## St Quintin and Woodlands Neighbourhood Forum

### **APPLICATION PP/24/05920 UNIT 9 LATIMER ROAD W10 REPRESENTATION FROM THE ST QUINTIN AND WOODLANDS NEIGHBOURHOOD FORUM/ ST HELENS RESIDENTS ASSOCIATION**

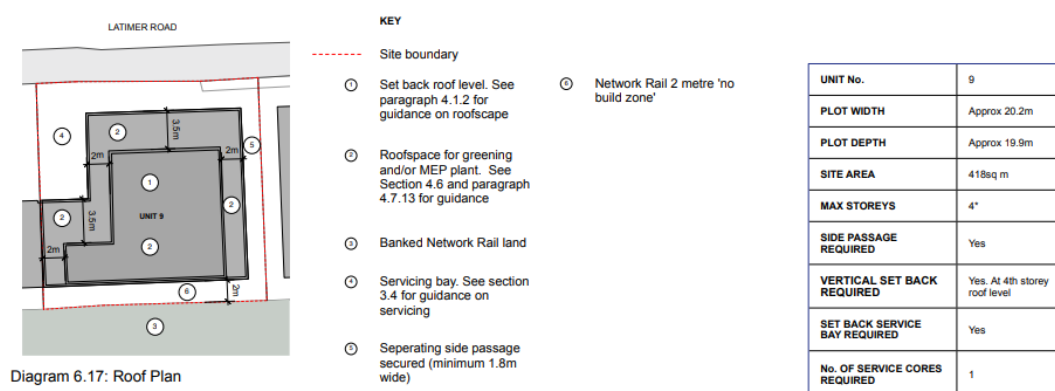
- The section below shows the impact of reduced daylight/sunlight on the houses opposite, with a three storey building plus a set back fourth. A separate objection from Latimer Road residents questions the assumptions in the Daylight/Sunlight study on impacts for Nos 276-282 Latimer Road. The cumulative impact of additional redevelopments at five rather than four storeys must also be considered.

## 6.9 Unit 9

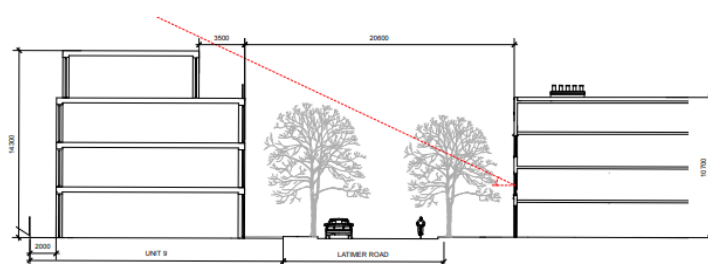
The RBKC Design Code includes diagrams and guidance on ‘model plots’ of each of the Units. That for Unit 9 is below. **While only ‘guidance’ as opposed to ‘policy’ several important aspects do not feature in the proposals in application PP/24/05920**

- The existing light industrial building is set back from the site boundary line. This position appears to be retained in the proposed ground floor plan but this is not clear. The drawings are scaled but with no dimensions, and are simplistic for a major development.

- The residual service yard is small and is shown with two trees planted in it. As recognised in the Design Guide, these yards play an important part at present in breaking up massing in the street, and admitting more daylight/sunlight. In mixed use buildings these service areas will be needed for the increasing number of deliveries to seven flats in the building, without causing traffic congestion in the street.
